## SYDNEY CENTRAL CITY PLANNING PANEL COUNCIL ASSESSMENT REPORT

<b>Panel Reference</b>	PPSSCC-324
<b>DA Number</b>	DA/1/2022
<b>LGA</b>	City of Parramatta (formerly Hornsby Shire Council)
<b>Proposed Development</b>	30 storey mixed use building comprising 2 storey commercial podium (retail unit, 60 children centre-based child care facility and commercial office space) and a shop-top housing tower above comprising 211 apartments, 6 basement levels providing 317 car parking spaces, landscaping and public domain works. The proposal constitutes stage 2 detailed design of concept plan approval DA/314/2017.
<b>Street Address</b>	37 – 41 Oxford Street, EPPING NSW 2121 (Lot 2 DP 1205413)
<b>Applicant</b>	Meriton
<b>Owner</b>	Karimbla Properties (No. 59) Pty Ltd
<b>Date of DA lodgement</b>	24 December 2021
<b>Number of Submissions</b>	14
<b>Recommendation</b>	Refusal
<b>Regional Development Criteria</b>	The development has a capital investment value of more than \$30 million.

<b>Clause 4.6 requests</b>	<ul style="list-style-type: none"><li>• Hornsby Local Environmental Plan 2013</li><li>• Clause 4.3 – Height of Buildings</li><li>• Clause 4.4 – Floor Space Ratio</li><li>• B2 Local Centre Z

Figure 3. Proposed Ground Level Plan and 3D Render.

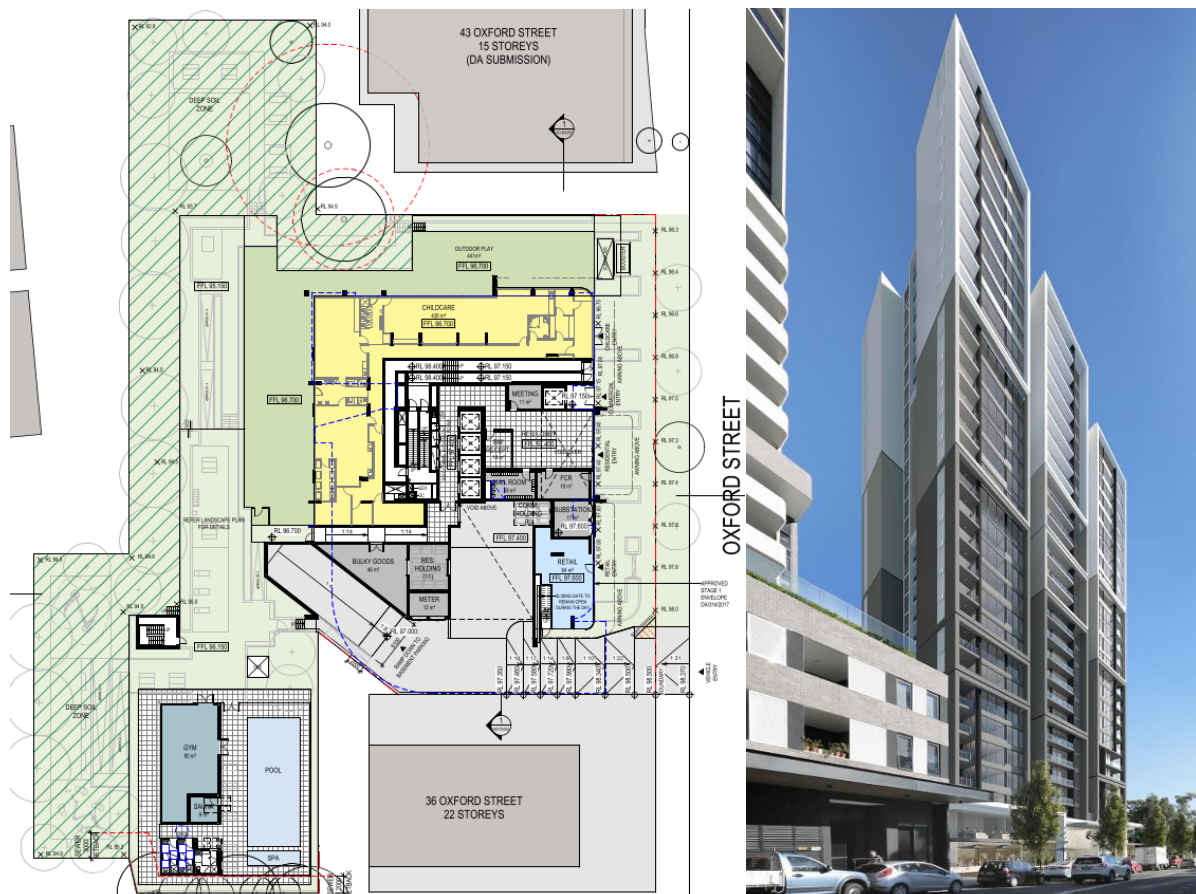
The podium design is not considered to be appropriate as it will be out of scale and alignment with adjoining podiums and the proposed tower.

- **Podium** –
  - **Height** – 2 storey podium inconsistent with concept, DEAP advice and two adjoining buildings (3 storeys)
  - **Front Setback** – 7.3m setback not consistent with concept (4.5m), previous DEAP advice (3m) and two adjoining buildings (0m south, 3m north)
  - **Side Setback** – 9m south side setback not consistent with control/concept (0m)
- **Parking** –
  - Excessive car parking (97 excess)
  - Insufficient bicycle parking (169 deficient)
  - No end-of trip facility proposed
- **Landscaping** – No tree planting in front setback (7 required by concept)
- **Accessibility** – Parts of communal open space not step-free, lack of diversity in size of adaptable units
- **Wind** – Concerns with modelling
- **Reflectivity** – Concerns with modelling
- **Stormwater** – OSD design not appropriate. No WSUD features.

Figure 5. Proposed breach of height limit (red line represents approximate 72m height standard).

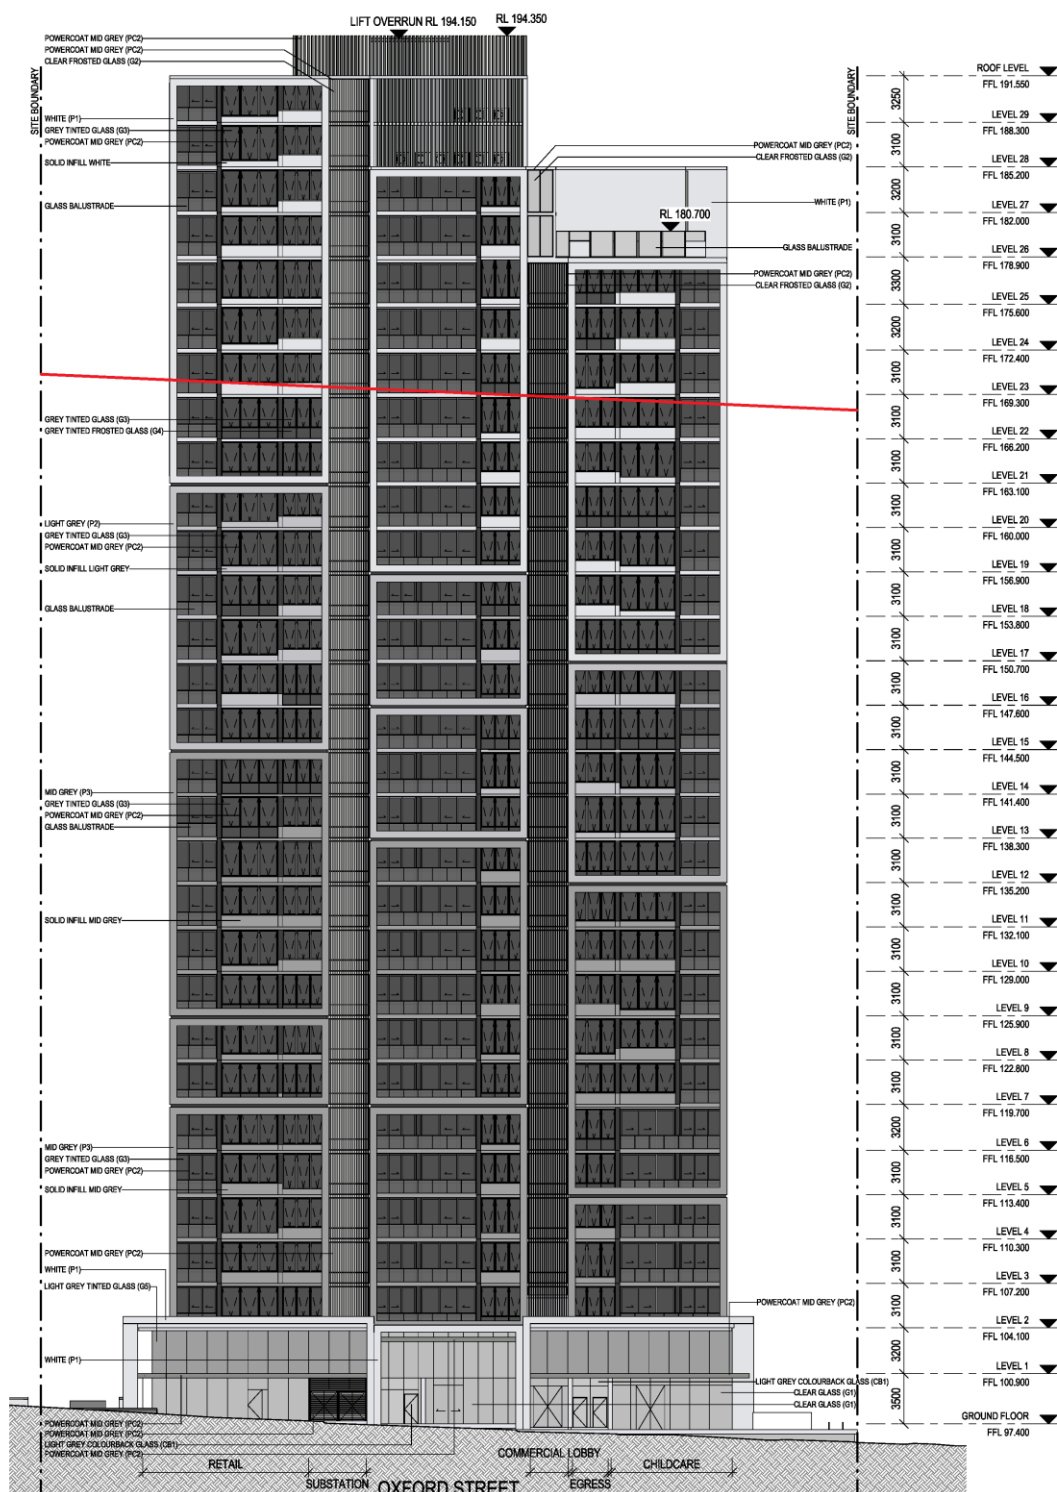
The proposal does not comply with the Clause 4.3 'Height of Buildings' development standard, as outlined in Section 7.8 above and figure 5 below, and as such the applicant has submitted a request to vary the height standard under Clause 4.6 of the HLEP 2013.

It is considered that the applicant's written request does not demonstrate sufficient environment planning grounds as it does not include the site-specific benefits outlined in the concept request. In particular, it does not include the ESD improvements and front setback tree planting that in part justified the original breach.

- There are not sufficient environmental planning grounds to justify the departure, in particular the lack of ESD improvements and front setback tree planting that justified the concept breach.
- The proposal will not be in the public interest due to the proposal's inconsistency with the B2 zone objectives. In particular, the proposal does not adequately maximise public transport patronage, walking and cycling.
